Access Compliance Report

Public Rights-of-Way

(Pedestrian Signals)

Intersection ID: N/A	Main Street:	Cross Street: N/A	Location: N/A
ADA ID: DB3896BA516F	Signal Type: One Push Button-Non APS	Overall Compliance: No	Severity Score: BTN 1: N/A BTN 2: N/A No BTN: N/A
Codes/Mitigation Info/Possible Solution		Field Measurements/Component Compliance

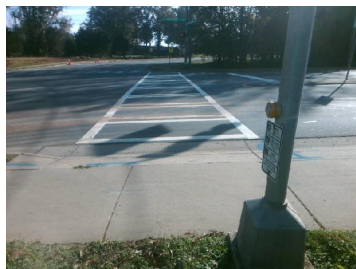
Yes	B 1 Clear Xing Direction?	ClearlyMarked	N/A	B 2 Clear Xing Direction?	N/A
	B 1 Crossing Direction	To E		B 2 Crossing Direction	N/A
Yes	B 1 DistanceTo XWalk (in)	0.0	N/A	B 2 DistanceTo XWalk (in)	N/A
No	B 1 DistanceTo Curb (in)	96.0	N/A	B 2 DistanceTo Curb (in)	N/A
Yes	B 1 Diameter (in)	2.0	N/A	B 2 Diameter (in)	N/A

Possible Solutions: Replace Signal Push Button With APS Button on New Post. Remove & Relocate Sign.

PROW/ADA: TMUTCD 4e.08
